TE Connectivity

Product Change Notification: PCN-26-283219

Type III contacts and Posted connector assemblies

Plating Condition Descriptions Resulting from Product Change

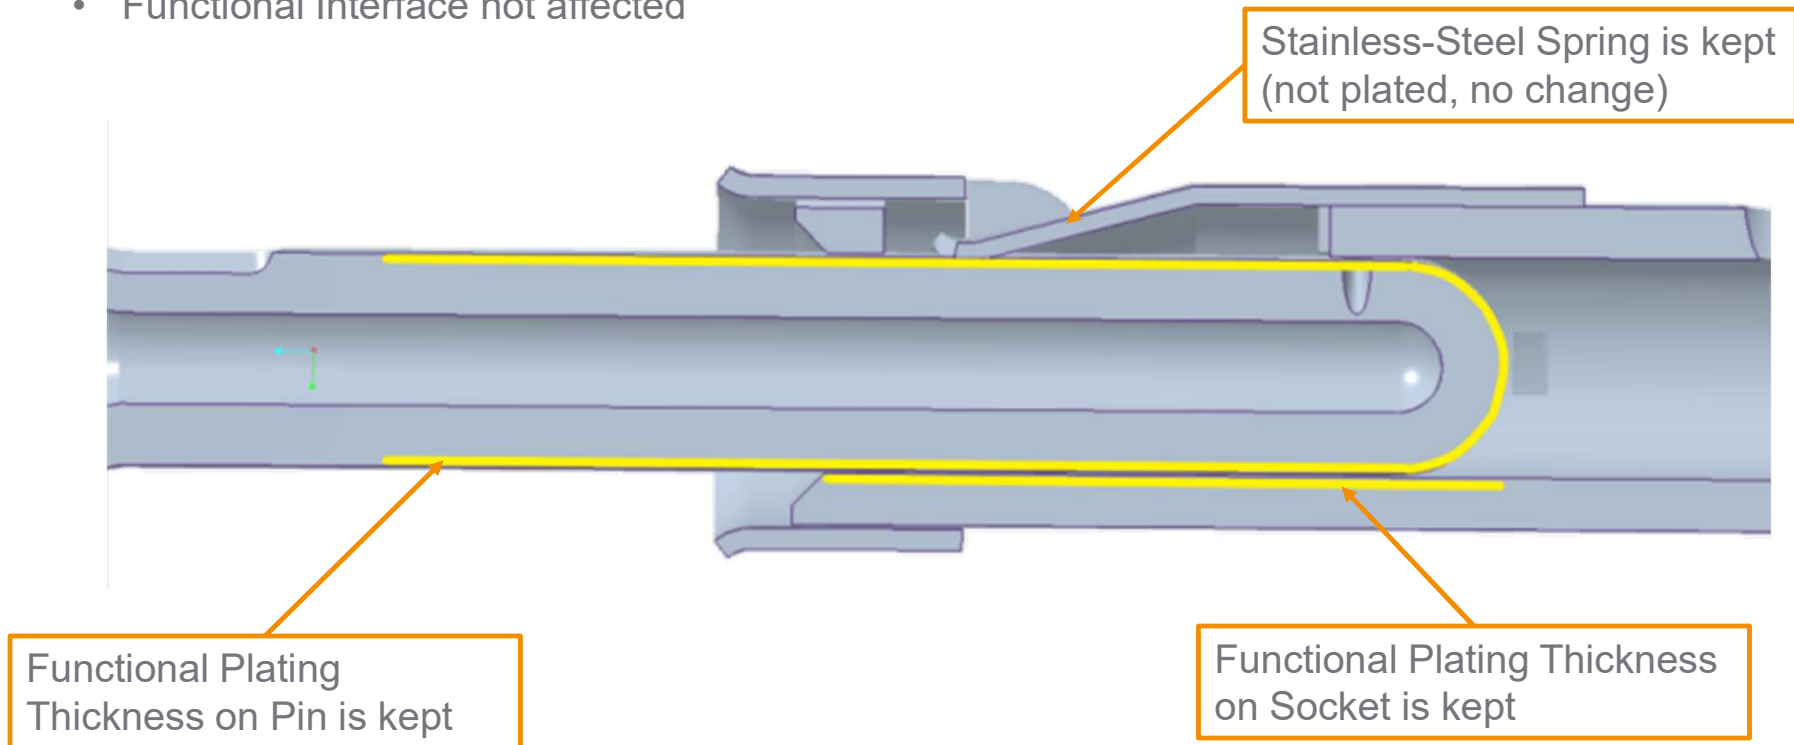
Functional area [mating interface] plating not affected
Matte Tin on crimp area
All over Nickel

Functional area [mating interface] plating not affected
Gold Flash on contact body
Matte Tin on crimp area
All over Nickel

Functional area [mating interface] plating not affected
Gold Flash on the remainder
All over Nickel

Functional (mating interface) plating thickness specific to each PN is not affected by this product change.
50 μ m minimum Matte Tin isolated to crimp area.
75 μ m Nickel all over and as an underplate to Au and Tin

- Functional Interface not affected
